Planning Division
15151 E. Alameda Parkway, Ste. 2300
Aurora, Colorado 80012
303.739.7250

February 16, 2021

Re: Initial Submission Review – King’s Point South PAs 1-4 – Site Plan and Plat
Application Number: **DA-1628-04**
Case Numbers: **2021-4001-00**

**TOPOGRAPHY TOOL KIT
ACCOMMODATING SLOPES
ALONG STREETS**

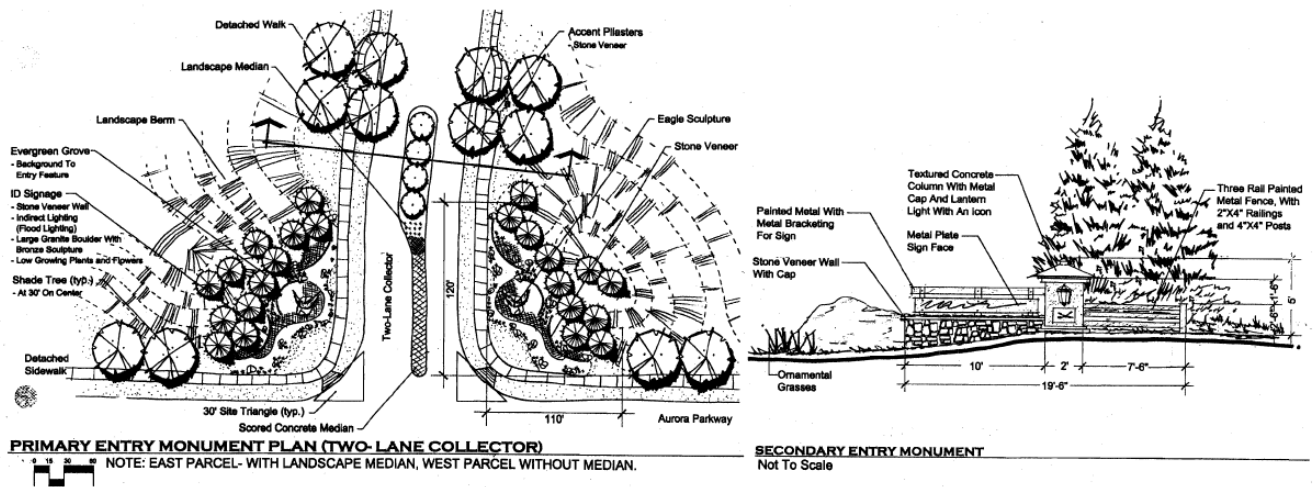
- 3C. In addition to the topography toolkit, subdivision standards in the Unified Development Ordinance will be applicable to this development. Section 146-4.3.5.B requires that grading on or near ridgelines and swales shall maintain the approximate topographic. Significant reconstruction of prominent topographic features shall be avoided.
- 3D. Section 146-4.3.17.A requires that parks and open space shall be located on prominent high points with significant views. The proposed park and open space at the heart of the development will advantage of the views of the Front Range meets this criterion.
- 3E. The Public Improvements Plan calls out required improvements for Phase 1 neighborhood. In this particular case, King's Point South is required to provide a right-in, right-out connection to East Aurora Parkway when it is constructed.
